## Grandview Reserve Master Development Drainage Plan

**Engineering Review**

**EPC Planning & Community  
Development Department**

SKP-20-001

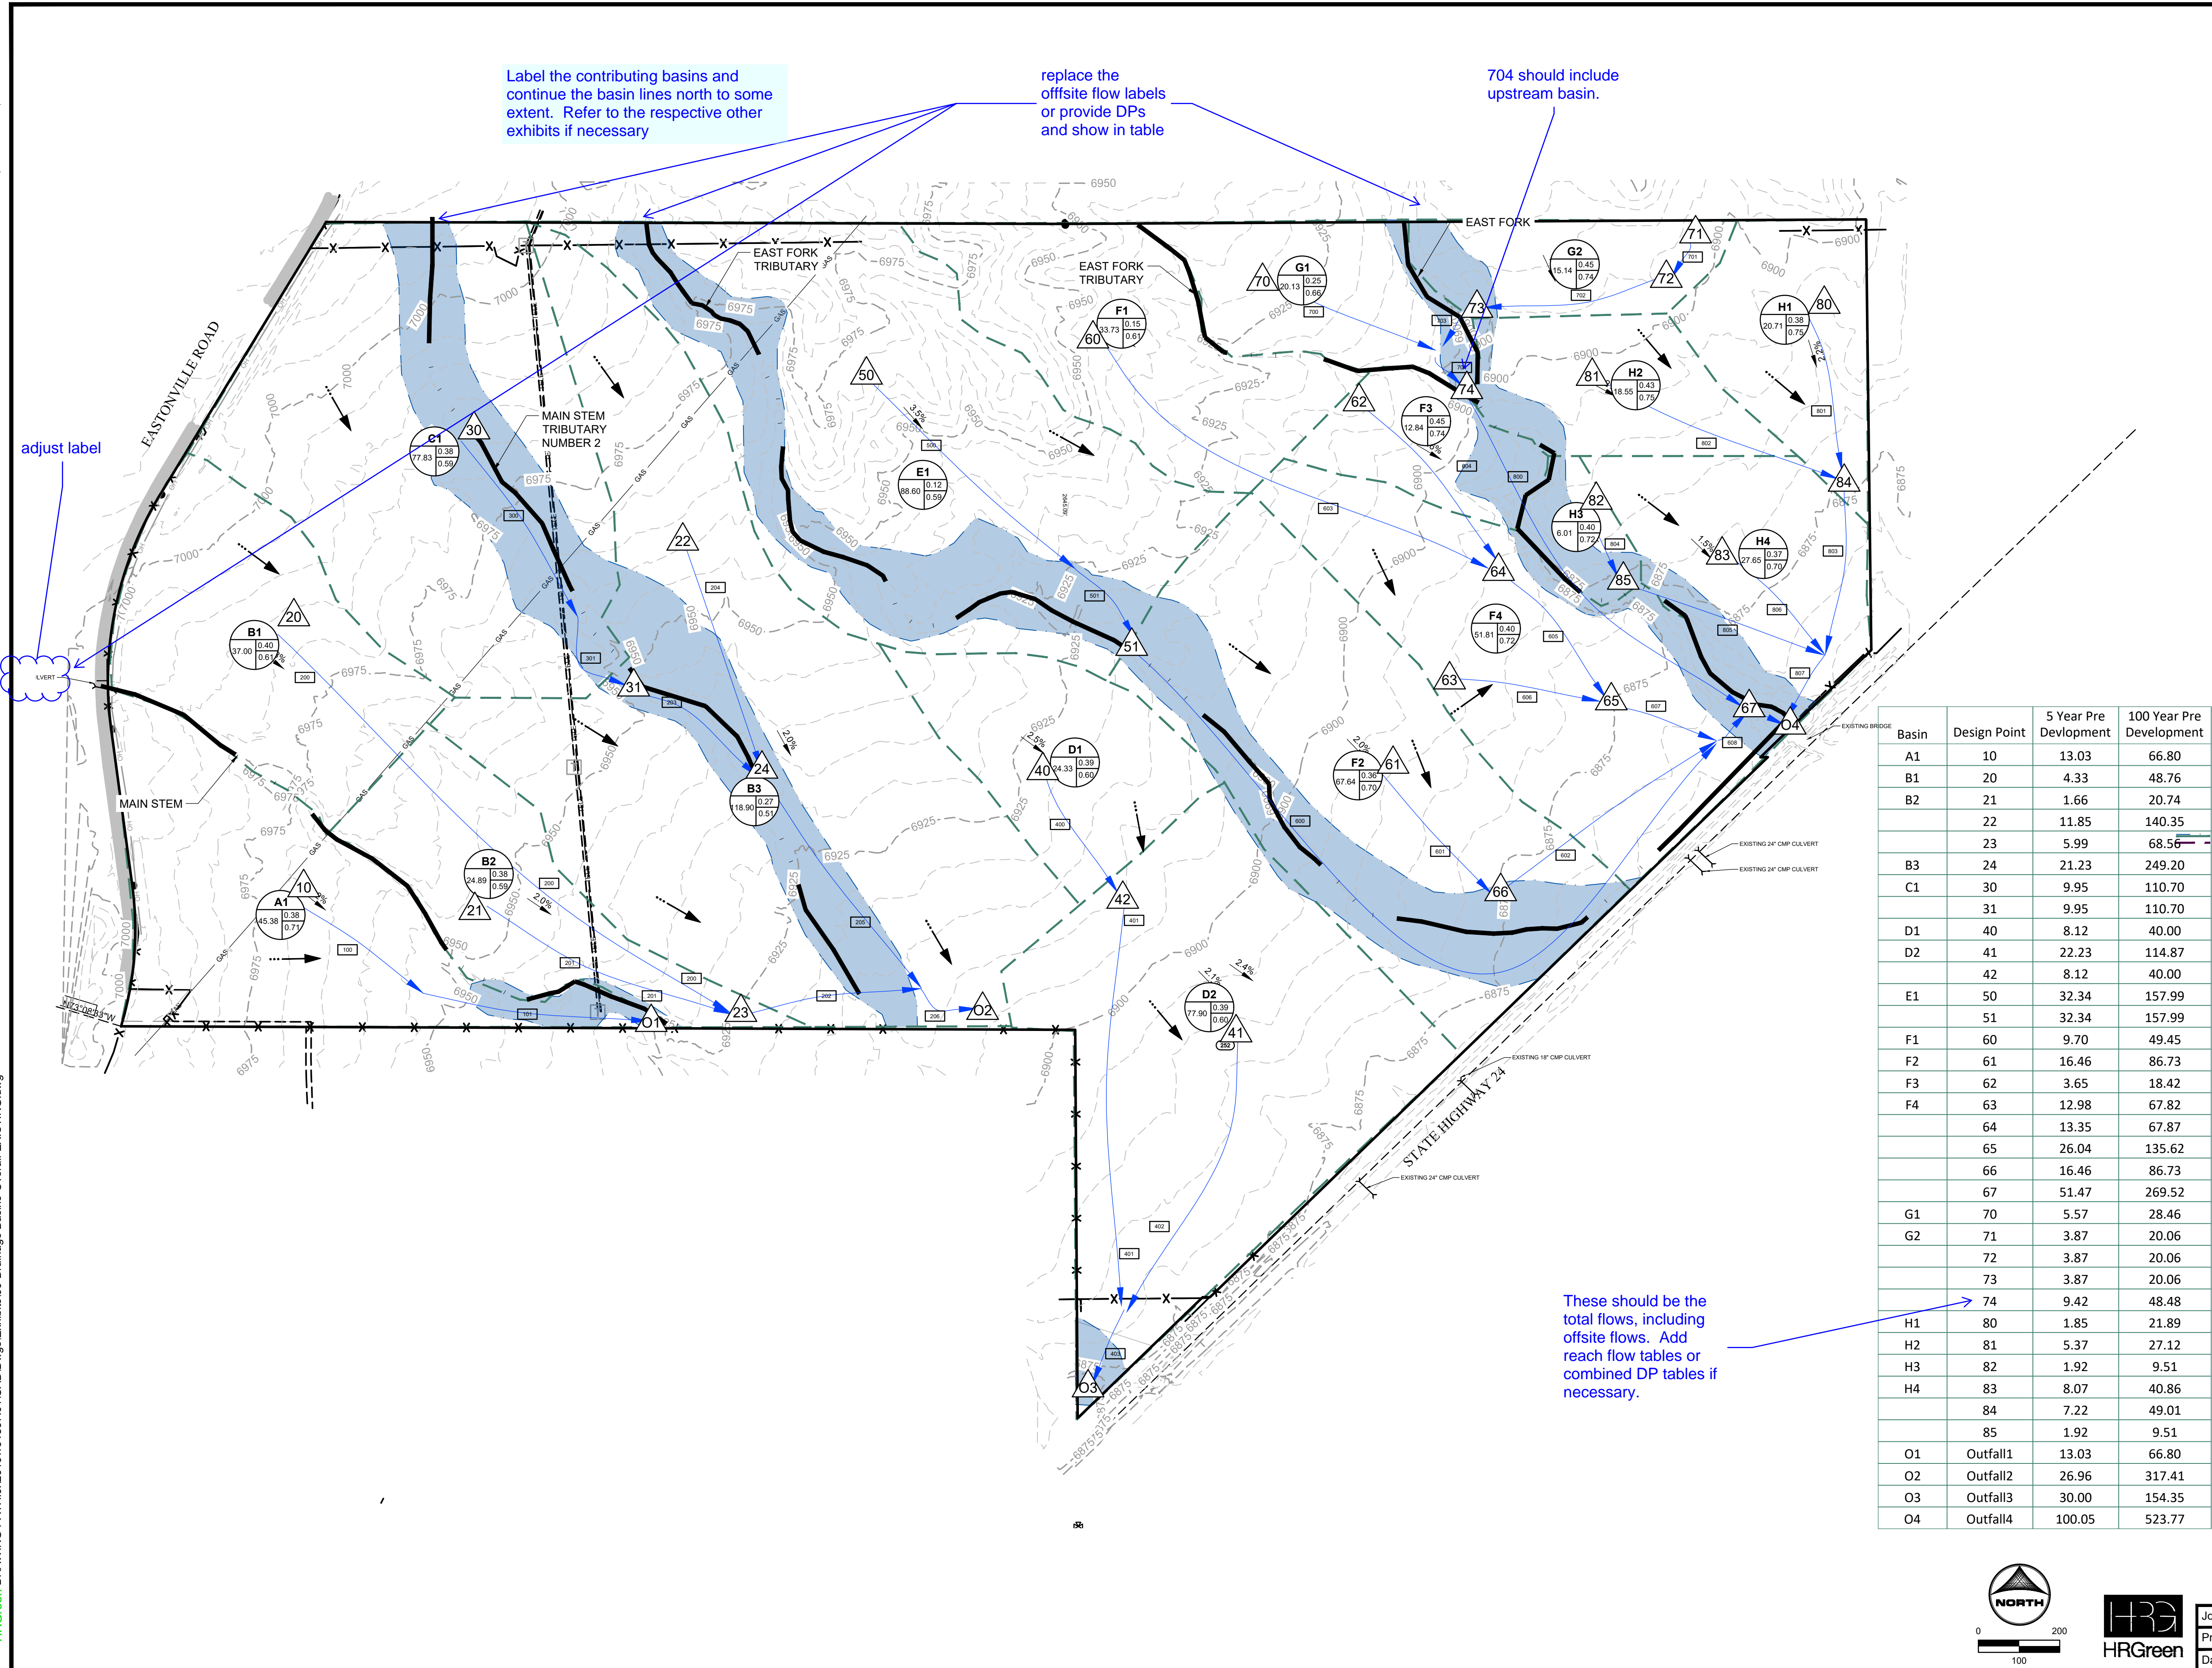
These should be the total flows, including offsite flows. Add reach flow tables or combined DP tables if necessary.
